City of Portland, Maine - Building or Use Permit Application
389 Congress Street, 04101 Tel: (207) 874-8703, Fax: (207) 874-8716

Permit No: 010500	Issue Date: MAY 17 2001	CBL: 389 E014001
----------------------	----------------------------	---------------------

Past Use: Single Family	Proposed Use: Same; Replace Existing 12' X 12' Deck with 14' X 22' Deck. Call John Ponger at 998-4406 when ready.	Permit Fee: \$54.00	Cost of Work: \$5,000.00	CEO District: 2
Proposed Project Description: Replace Existing 12' X 12' Deck With New 14' X 22' Deck.		FIRE DEPT: <input type="checkbox"/> Approved <input type="checkbox"/> Denied	INSPECTION: Use Group: A-3 PERMIT ISSUED: 5/17/01 WITH REQUIREMENTS	
		Signature:	Signature:	
		PEDESTRIAN ACTIVITIES DISTRICT (P.A.D.)		
		Action: <input type="checkbox"/> Approved <input type="checkbox"/> Approved w/Conditions <input type="checkbox"/> Denied		
		Signature:	Date:

DATE: 10 May 2001 ADDRESS: 40 Sturdivant Dr. CBL: 389-E-014

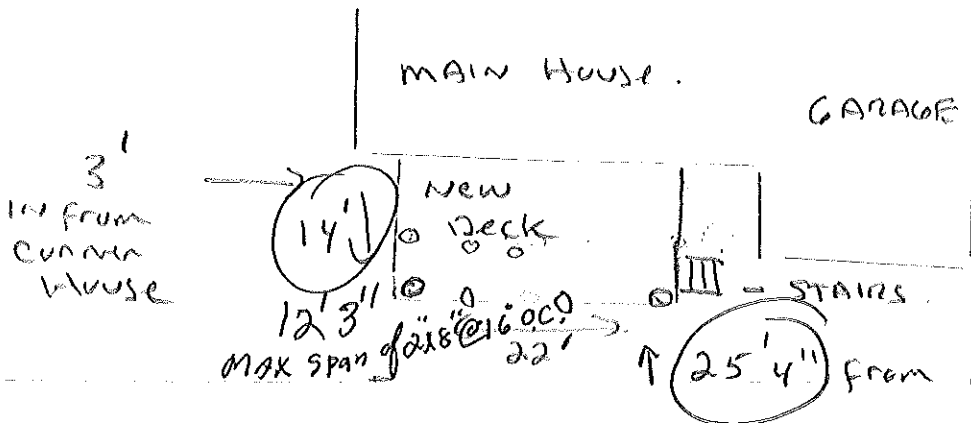
↑ 27'4" from property line

GIRDER triple 2x10
front, ✓
Secondary girder ✓
under mid left ✓
section triple 2x10.
6 concrete filled
tubes 4' deep.

FRAME 16" oc 2x8 ✓

4x4 post support girder ✓

ledger against house with joist hangers ✓

Solid bridging leads 16" oc to reverse deck boards
to avoid ANY splices. ✓

STAIRS 2x12 Tread. 2x12 stringers ✓

RAILS Around entire deck. 34" High from deck ✓

with balusters spaced 4" APART. ✓

42
see
attached

R-2 Zone

check →
Front: N/A
REAR: 25' req - 25'4" shown
side: 12' req - appears to have 12'

<i>with condition that the side setback be 12'</i>

- 32. Please read and implement the attached Land Use Zoning report requirements. *side setback shall be a minimum of 12 feet*
- * 33. Boring, cutting and notching shall be done in accordance with Sections 2305.3, 2305.3.1, 2305.4.4 and 2305.5.1 of the City's Building Code.
